Enclosure 2
Revision to COLA Section 3.8

Enclosure 3
Revision to COLA Section 3H.6

3H.6.7 Diesel Generator Fuel Oil Storage Vaults (DGFOVS)

RAI 03.08.04-30, Supplement 1**QUESTION:****Follow-up to Question 03.08.04-23**

Figure 3H.7-5: SSI, SSSI, ASCE 4-98 and Design Lateral Seismic Soil Pressures (psf) on Fuel Oil Tunnel East Wall with Reactor Building and Crane Wall

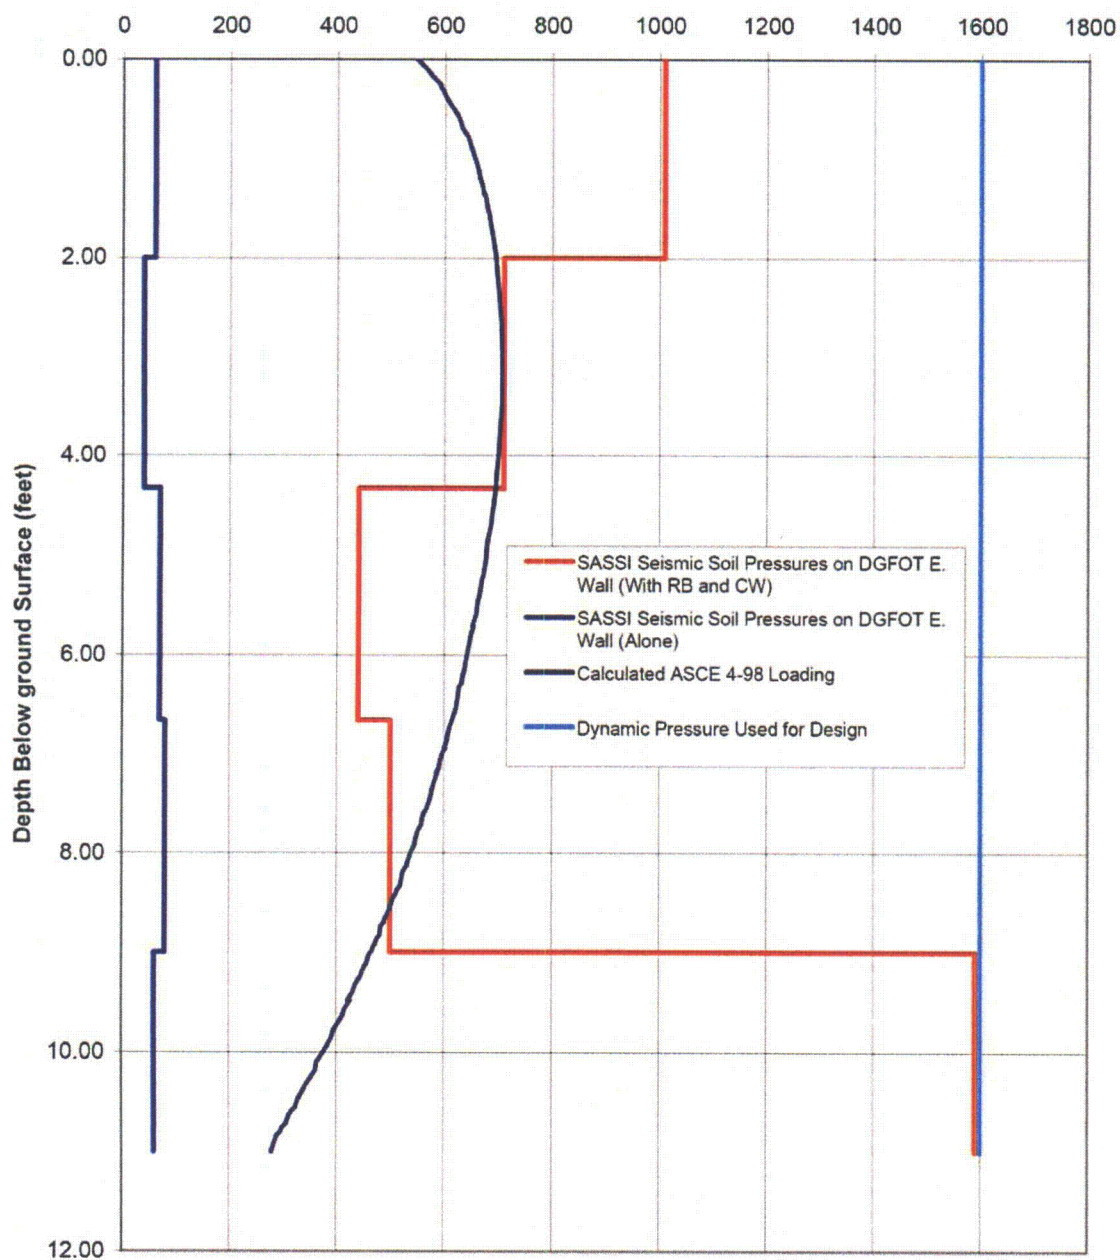
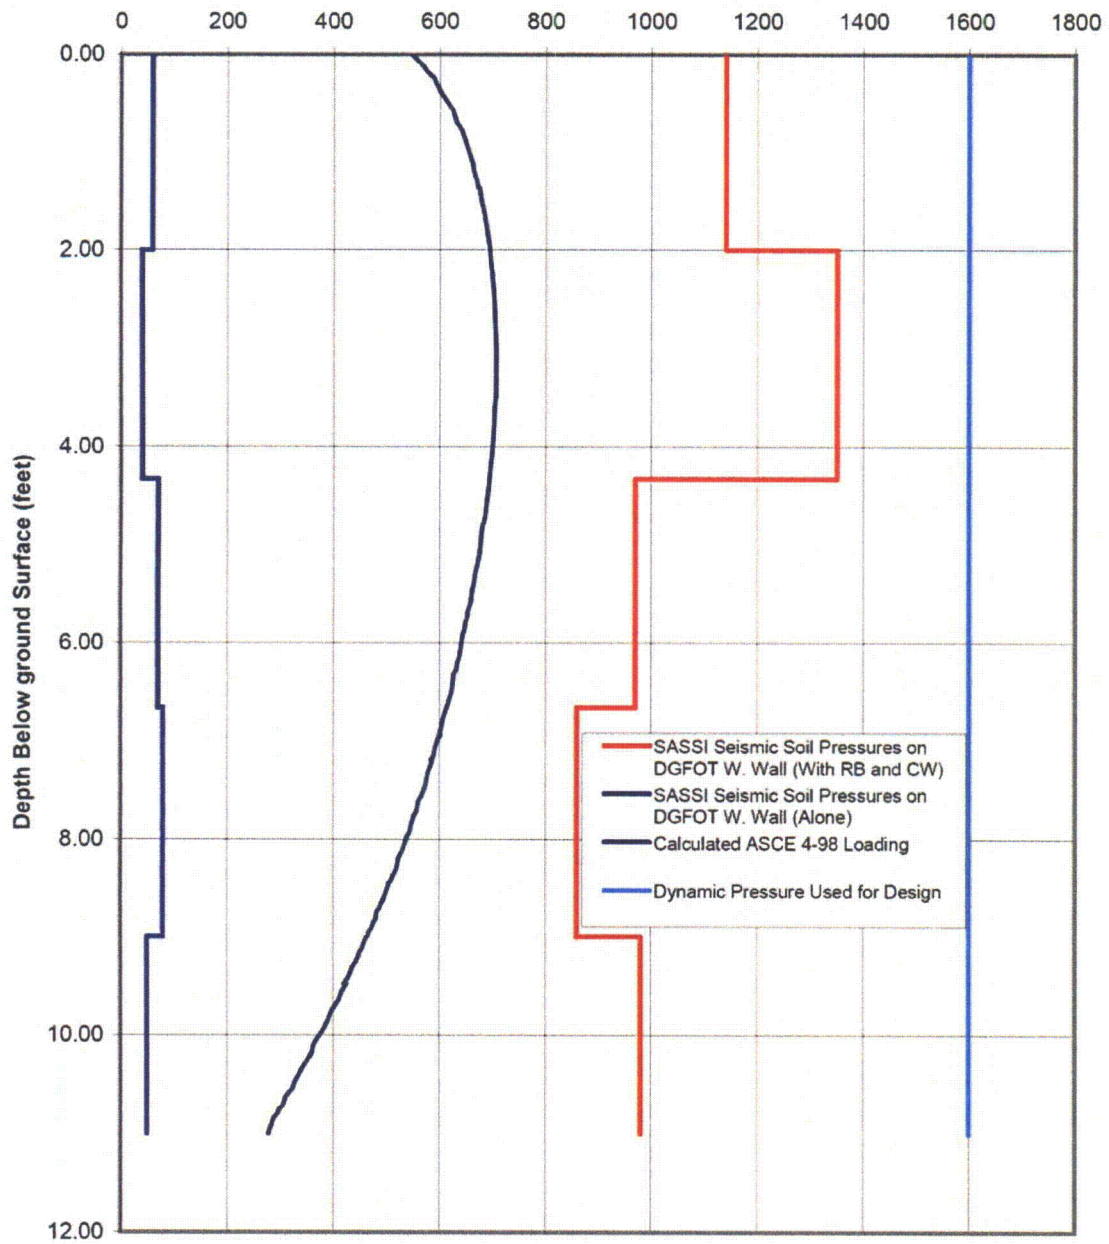
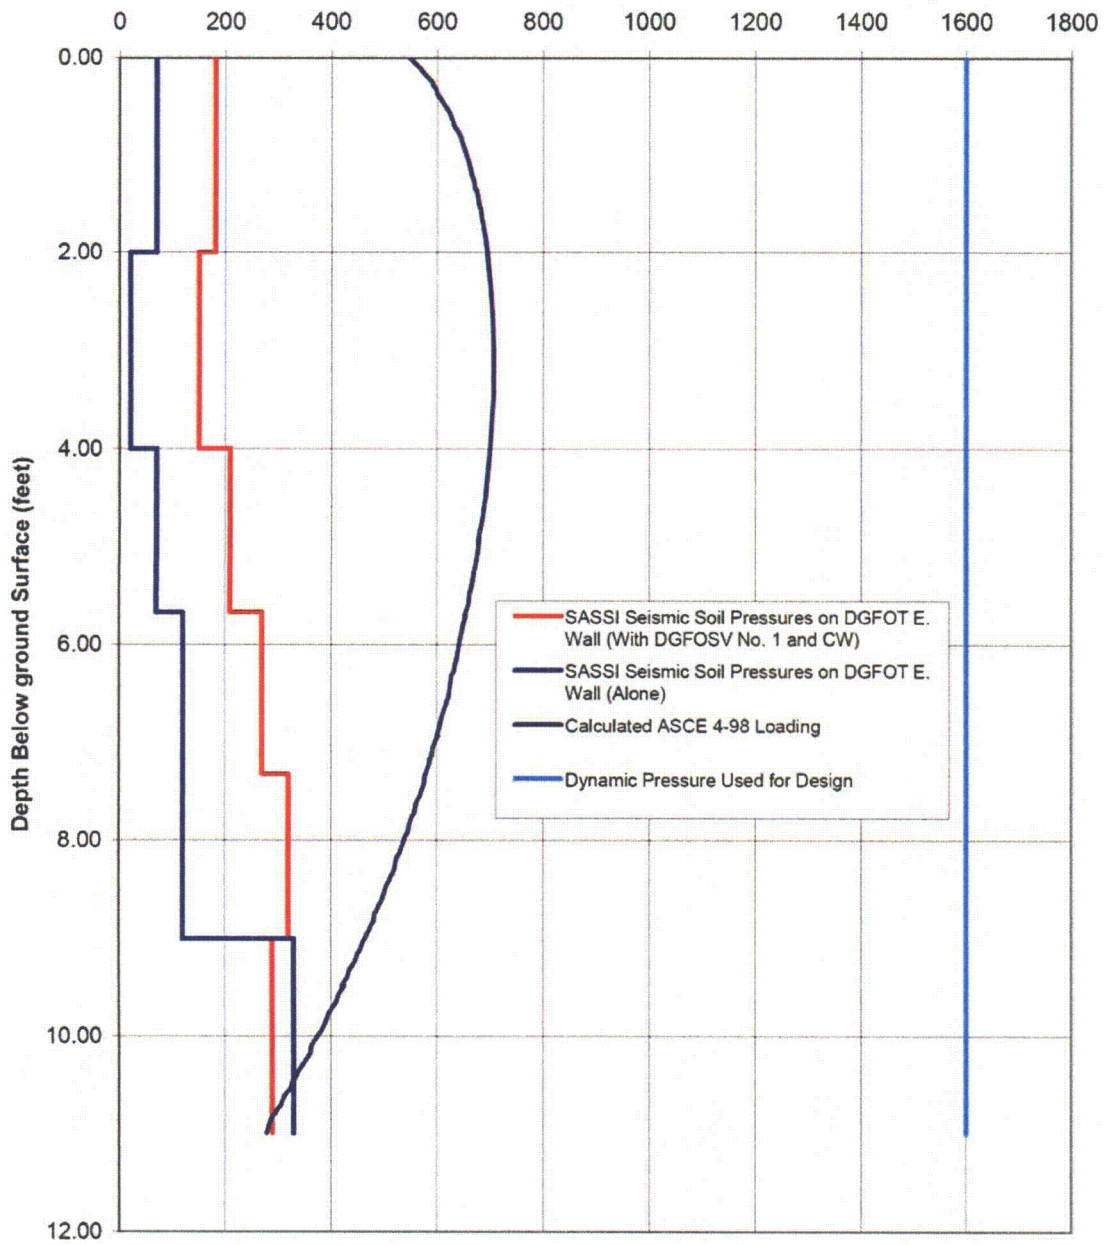
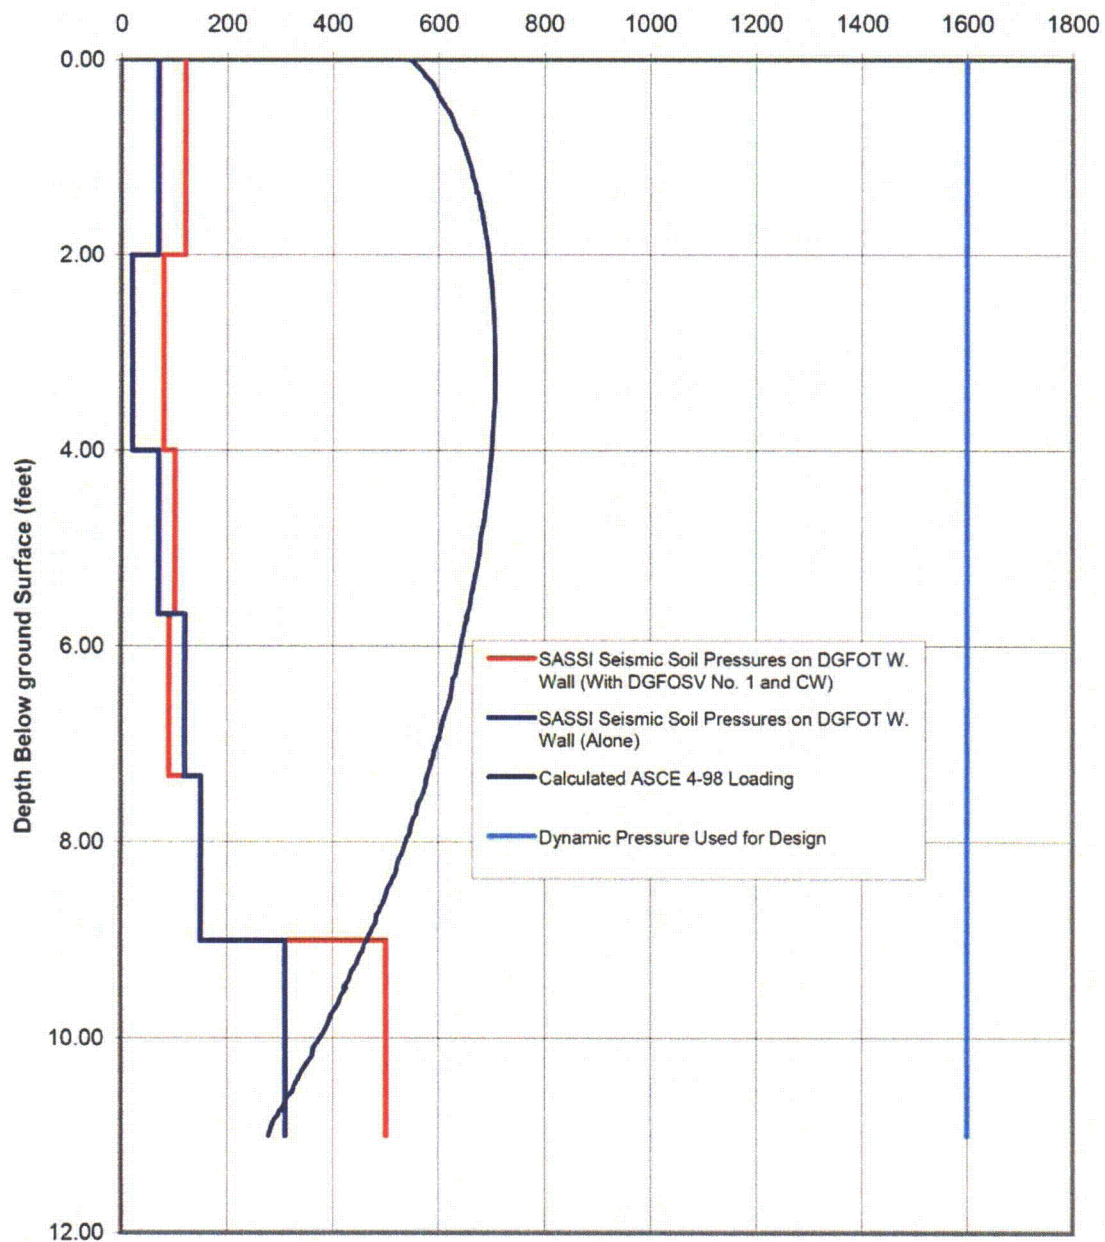
Figures 3H.7-5 through 3H.7-8 show a comparison of the SSI, SSSI, ASCE 4-98 seismic soil pressures and the enveloping seismic soil pressures used for the design of the DGFOT walls.

Figure 03.08.04-30.2: Horizontal section cut elevations

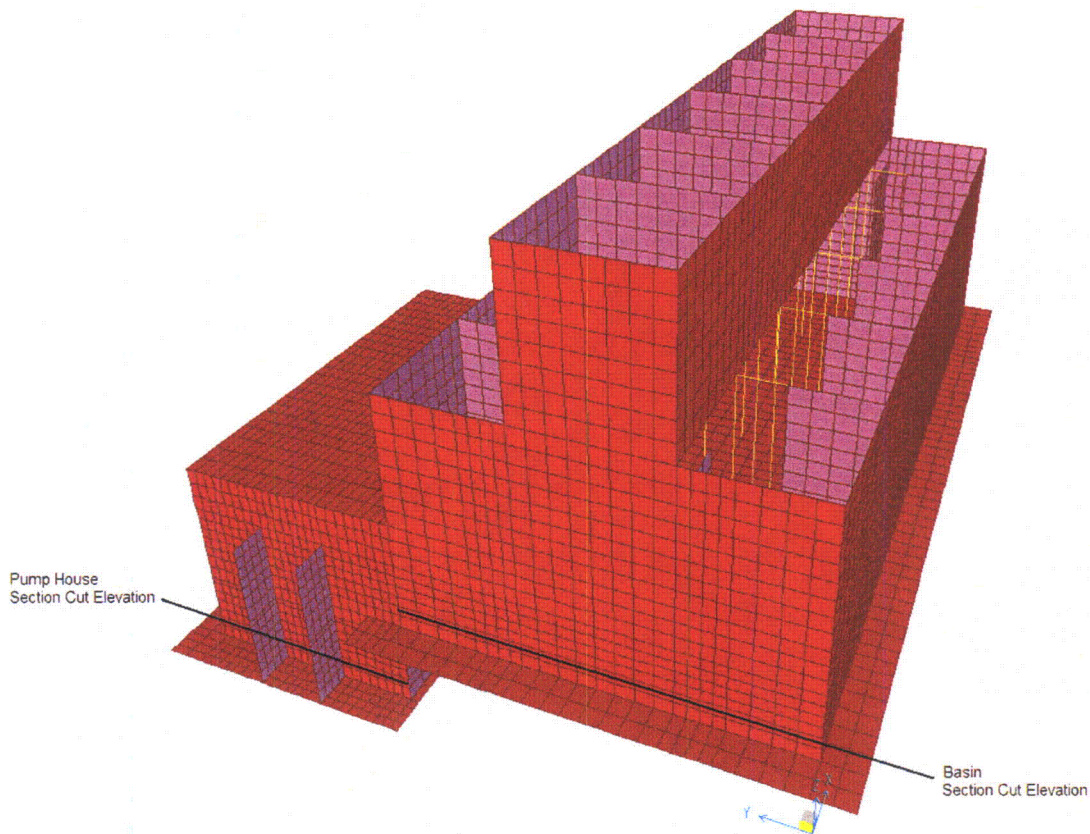
Horizontal section cut elevations at the base of the Ultimate Heat Sink (UHS) Basin and the base of the Reactor Service Water (RSW) Pump House for comparison of forces and moments from the SSI model and the equivalent static FEA are shown in Figure 03.08.04-30.2. A comparison of the forces and moments at these section cuts from the SSI analysis and the SAP2000 equivalent static FEA are provided in Tables 03.08.04-30.3 through 03.08.04-30.6. As shown in these tables, the ratio of equivalent static FEA forces and moments to the SSI analysis forces and moments is greater than 1.0; therefore, the design forces used in the equivalent static FEA envelop the maximum SSI analysis forces.

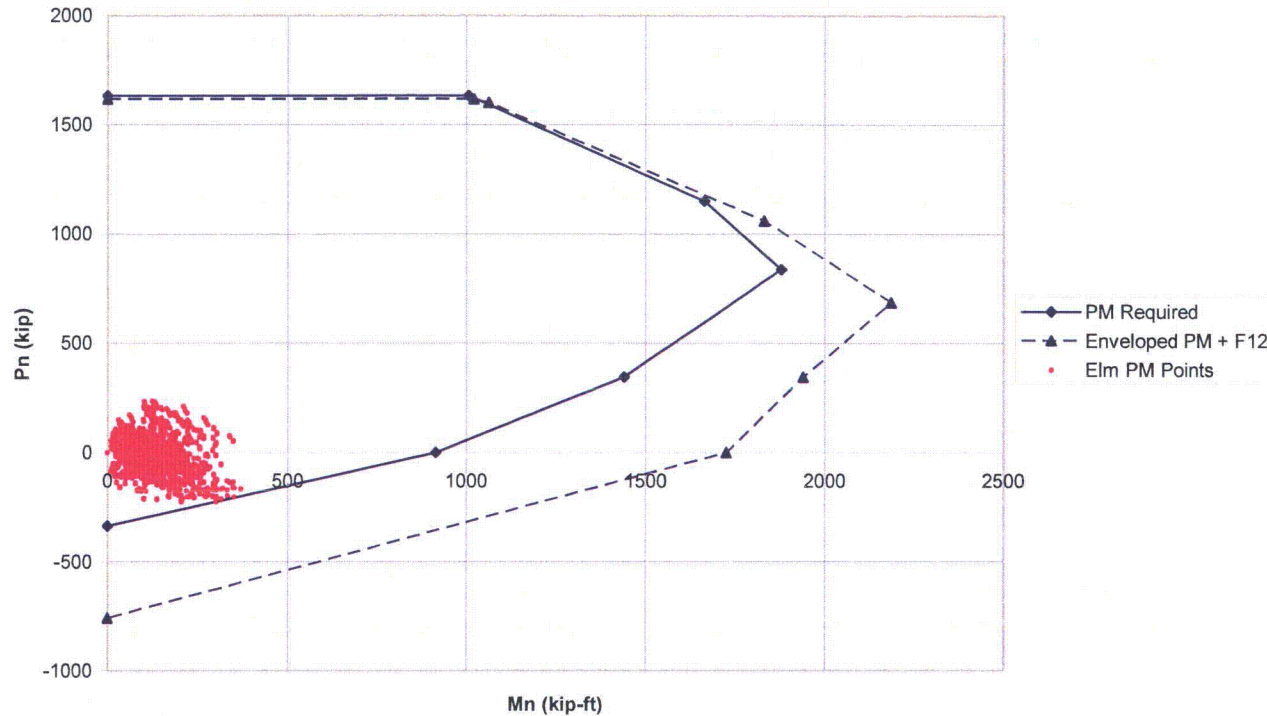
The concrete cross sections corresponding to Element 1880 in Table 03.08.04-30.9 are shown in Figures 03.08.04-30.5 and 03.08.04-30.6 for the required reinforcement (shown in red) based on axial forces and moments only and for the provided reinforcement (shown in red) based on axial forces, moments, and in-plane shears, respectively.
